Report of Planning and Economy to the Ordinary Meeting of Council held on Monday 18 September 2017

PE1 - Development Application No: DD010.2016.00000808.001 for Multi Dwelling Housing containing 2 Single Storey and 12 Two Storey Dwellings and Strata Subdivision – 56 & 58 Carlton Road, Thirlmere

PE1 **Development Application No: 010.2016.00000808.001 for Multi Dwelling Housing containing 2 Single Storey and 12 Two Storey Dwellings and Strata Subdivision – 56 & 58 Carlton Road, Thirlmere**
 277598 DD010.2016.00000808.001

Figure 2. Proposed Site Plan

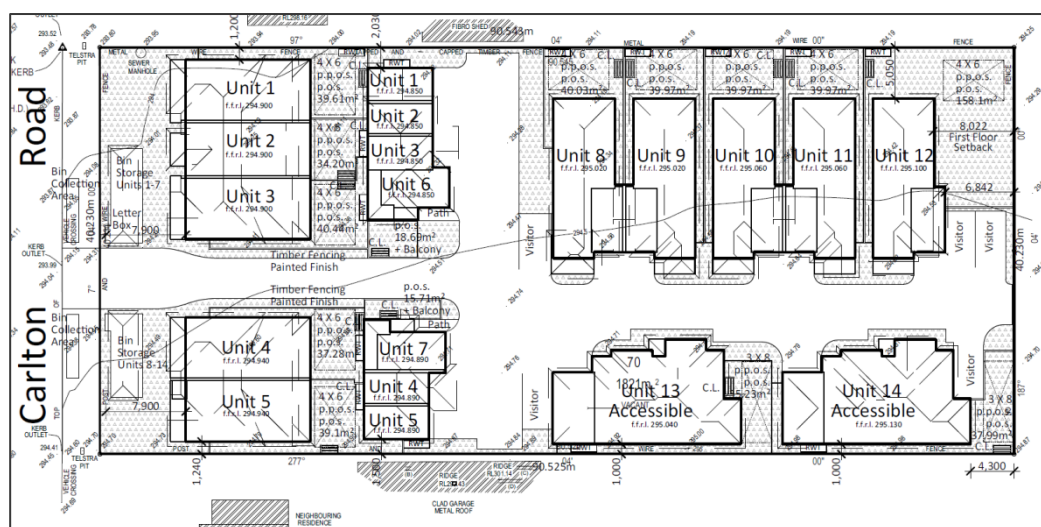
Proposed Variation: Front Setback

Volume 4, Clause 3.17 Medium Density Development Setbacks Control 18, requires the front setback to be the average of the setback on the two adjoining lots, plus or minus 10%.

Based on the existing setbacks on the adjoining lots, a minimum setback of 10.9125m is required.

The application proposes a front setback of 8.5m to Carlton Road.

The variation is 2.4125m, or 22%.

Proposed Variation: Private Open Space

Clause 3.17 Medium Density Development Private Open Space Control 29 requires that a minimum principal area of private open space must be provided for each dwelling with the following characteristics:

- Width no less than 3 metres in any direction
- Must be directly accessible from, and adjacent to, a habitable room, other than a bedroom (ie. a living area)
- Have an area no less than 24 square-metres.

Dwellings 6 and 7 have an entry at ground level, but are otherwise located at first floor level.

Proposed private open space is a combination of a small ground level area adjacent the entry and first floor balconies with access from living areas. The application proposes:

- Dwelling 6 Balcony areas = 18m^2 , ground floor private open space = 18m^2 , total = 36m^2
- Dwelling 7 Balcony area = 11m^2 , ground floor area private open space = 15m^2 , total = 26m^2 .

The numerical standards of the DCP are satisfied, in that more than 24m^2 of private open space is provided for each dwelling if the ground floor private open space is added to the balcony areas. Only the balconies are accessible from the living areas, meaning there is a variation to the DCP.

The calculation for private open space, excluding the ground floor areas, highlight the following variations:

- Dwelling 6 = 25% (24m^2 required, 18m^2 proposed)
- Dwelling 7 = 54% (24m^2 required, 11m^2 proposed).

Proposed Garbage Bin Bays

In assessing the application, and in discussion with the Team Leader Waste Management, the applicant was advised that the development was required to incorporate a bin bay adjacent the front boundary of the site, to facilitate waste collection.

The DCP Volume 4, Clause 3.17, and Controls 18 and 19 specify front setbacks to “proposed dwellings”. The bin bays are detached structures and are not “dwellings”, and it is considered that Controls 18 and 19 do not apply to the bin bay structure.

1. Not a variation to the DCP, as there is no relevant control that relates to bin bays, and the structures are provided in accordance with Control 45 relating to Waste Management, or
2. A variation to Control 26, which requires “building features” to extend no more than 1.5m in front of the building setback. In this case, the variation sought is to allow the structures to be 7.3m in front of the setback, a variation of 387%.

In the circumstances, the adoption of a setback to Carlton Rd of 8.5m for this development is considered appropriate for achieving the objectives of the standard and the variation is supported.

It is considered that the proposed balconies satisfy the DCP objectives for private open space. The variations are supported.

The proposal is considered to be a suitable and preferred design for the proposed development.

If the proposed bin bays are considered to be a variation, then the variation is justified because:

- a) The structures are to satisfy the DCP provisions in respect to Waste Management,
- b) The proposed structures are supported by the Team Leader Waste Management as the preferred arrangement for bin storage and waste collection from the site,
- c) The proposed structures are consistent with the preferred method of managing waste services for sites containing multi dwelling housing and/or residential flat buildings, and
- d) The DCP objectives will be achieved.
